Access Compliance Report

Public Rights-of-Way

(Pedestrian Signals)

Intersection ID: N/A	Main Street:	Cross Street: N/A	Location: N/A
ADA ID: 18488378EF91	Signal Type: One Push Button-Non APS	Overall Compliance: No	Severity Score: BTN 1: N/A BTN 2: N/A No BTN: N/A
Codes/Mitigation Info/Possible Solution		Field Measurements/Component Compliance

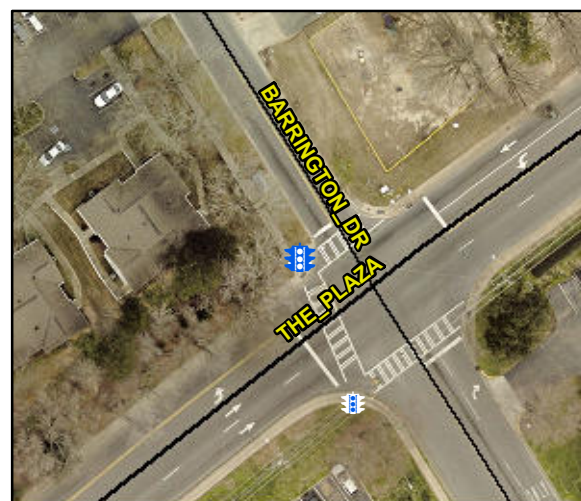
Surveyor Notes: TEXT HT 7/16,

PROW/ADA: R410.6, TMUTCD 4e.08, R404.2, R404.3, R406.2, R404.7.3

Possible Solutions: Replace Signal Push Button With APS Button on New Post. Remove & Replace Sign.
